Alberta Electric System Operator

Consolidated Written Feedback: Connection Requirements for Transmission-Connected Data Centres

(August 22 – September 19, 2025)

Section 6.4

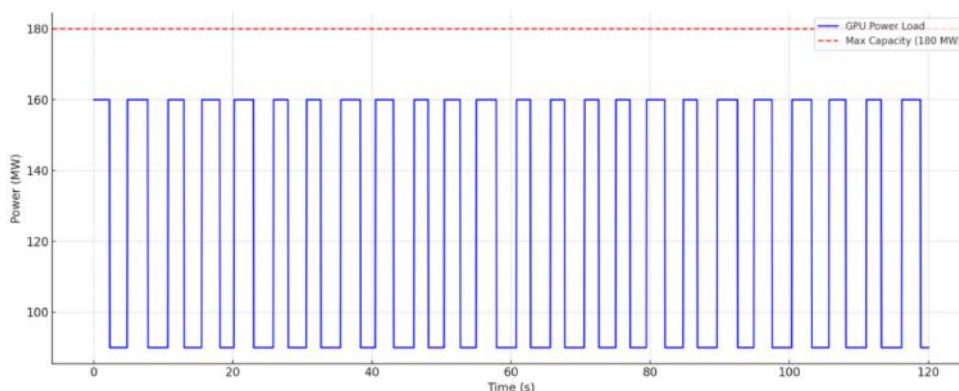
The TCDC must limit load ramping to maximum ramp rate of 10 MW/min.

Atlas' feedback on the proposed requirement that Transmission-Connected Data Centers (TCDCs) limit load ramping to a maximum of 10 MW per minute.

Both types of ramping must be carefully managed, but it is the fast, frequent, and bidirectional ramping of GPU clusters that presents the greatest challenge for system stability. If either facility support loads or computational loads are allowed to change too abruptly, they can create undesirable disturbances to the transmission grid.

The TCDC must limit the prevailing average for the facility to maximum change of 10 MW over a 1-minute period.

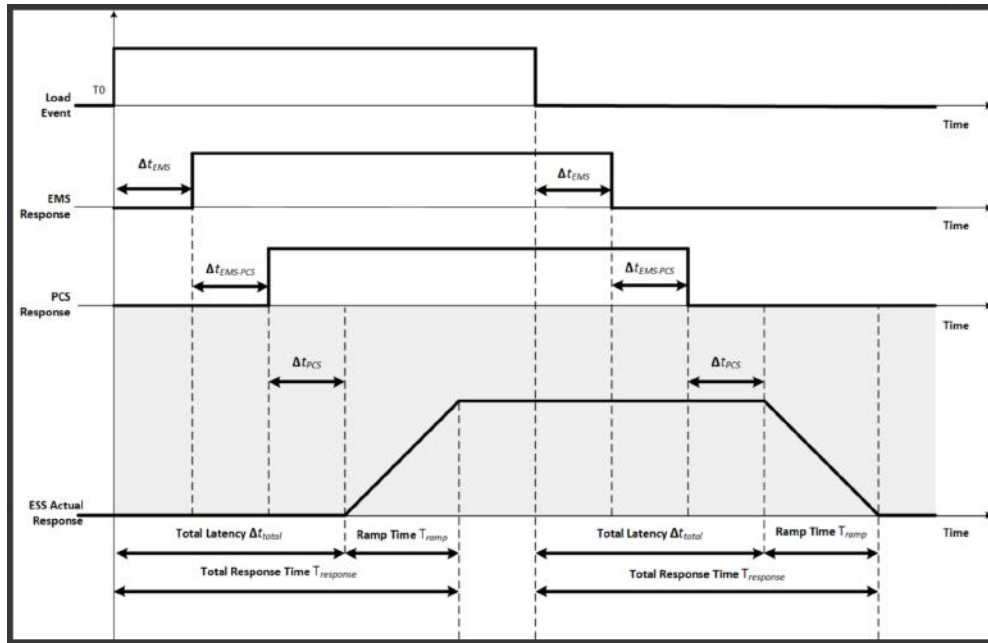
This type of frequency response is not an acceptable way to manage an AI Data Center load change as it is a lagging response, which has already subjected the grid, connected generators, and connected loads, to stresses including mechanical stresses, from the causation load change event.

Ensuring clarity here will avoid mismatches in interpretation, technical expectations, system design, as well as prevent cascading events that could exacerbate the problem leading to a more severe system failure.

- The acceptable latency response time limit should reflect achievable timeperiods, such as <300ms response constraint. This would be consistent and comparable to current FFR requirements.
- Consideration in MW for the initial mismatch in power change from a load change event, and the response, factoring latency, by the supporting power response systems to arrest this power change, both during an increasing or decreasing load.
- Load & local power system based power measurement and response, versus lagging frequency response.

- Implement load and power system measurement and control methodology (not exclusively frequency based control),
- limit the average load variance for the facility to maximum change of 1% of the facility rating (2.5 MW maximum) over any 500-millisecond period.
